Product Change Notification: E-20-016213

CAGE AND CONNECTOR ASSEMBLY, WITH EMI SPRING FINGERS

ZQSFP+ 2X Organizer Change

Organizer change

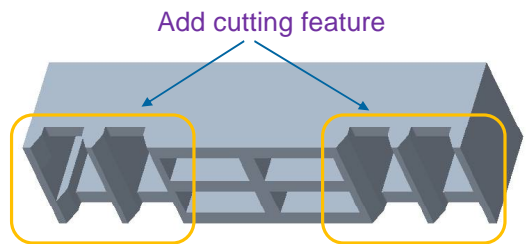
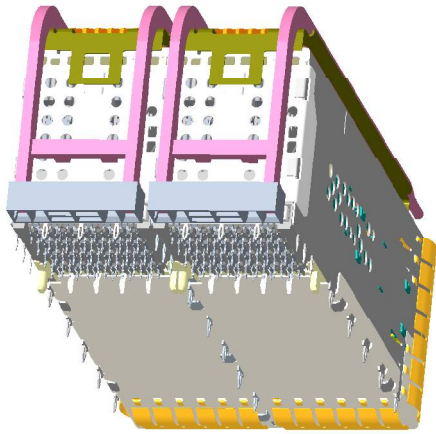
For easy removal of the light pipe in the platform application, the organizer structure is changed for ZQSFP+ 2X2 3-2299870-8 and 2X3 3-2299924-6.

Add cutting feature
